Detailed Site Plan
Departure from Design Standards
Alternative Compliance
Dash In at Marlboro Pike #1552

DSP-21009
DDS-687
AC-21022

SUBJECT: Detailed Site Plan DSP-21009
 Departure from Design Standards DDS-687
 Alternative Compliance AC-21022
 Dash in at Marlboro Pike

Figure 1: Site Plan

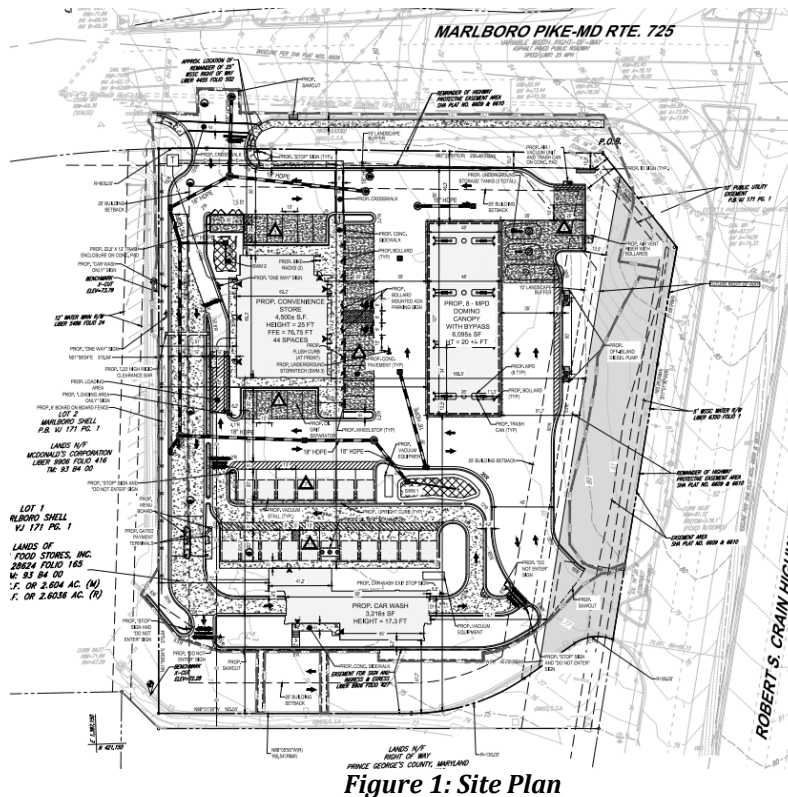
6. **Design Features:** This DSP proposes to construct a 4,508-square-foot food and beverage store, a gas station with eight multi-product fuel dispensers, and a 3,216-square-foot car wash. The site will have two access points: one located along MD 725 and one located along US 301. The proposed building and gas canopy are oriented facing US 301. The proposed plan shows dumpsters located behind the building on the northwest part of the site with a two-lane drive aisle leading to the car wash. The proposed 12-foot by 40-foot loading space is located between the rear of the building and the car wash drive aisle. The site is proposing a total of 44 parking spaces to include 2 handicap-accessible spaces and 2 bike racks. There will be 22 spaces that surround the food and beverage store and 4 additional spaces that are provided in the northeast corner of the site. There are 18 spaces that will also serve as vacuum stalls to accompany the car wash. A condition has been included herein, to request the removal of one parking space in front of food and beverage store to increase the width of the parking islands to provide additional trees to meet the landscape requirement.

As part of DSP-21009, the applicant filed a request for Alternative Compliance, AC-21022, relative to Sections 4.2.1, 4.3.1, 4.3-2, and 4.6 of the Landscape Manual. The applicant revised the landscape plan to meet the requirements of the Landscape Manual for Section 4.2, but has not yet satisfied Section 4.3. The site has an excess of parking spaces, and the Alternative Compliance Committee found that Section 4.3 could be satisfied with the removal of one parking space and the widening of the landscape islands to provide

- a. Revise the bearing for the western property line shown on the DSP to match the record plat.
 - b. Revise the height of the proposed freestanding pylon sign to 25 feet or revise the sign detail to reflect that there are three fuel types being proposed to meet the 50-foot height requirement.

- c. Revise the sign legend to correspond to the signs on the site plan. Provide the same labeling convention for both the legend and the plan.
 - d. Label the area of Lot 1 on Sheet 4 of the DSP in square feet and acres.

- e. Modify the site to expand the designated loading area, in order to facilitate safe and adequate truck turning maneuvers. The exact design and truck turning plans with design vehicle classification shall be evaluated and accepted by the Transportation Planning Section.

- g. Provide the exact dimensions of the buildings on the site plan.

- h. Add the street connection width for MD 725 (Marlboro Pike) to the site plan.
- i. Revise the landscape plan to conform to Section 4.3 by removing one parking space to the east of the food and beverage store, widening the planting islands five feet, and adding a shade tree to each island.
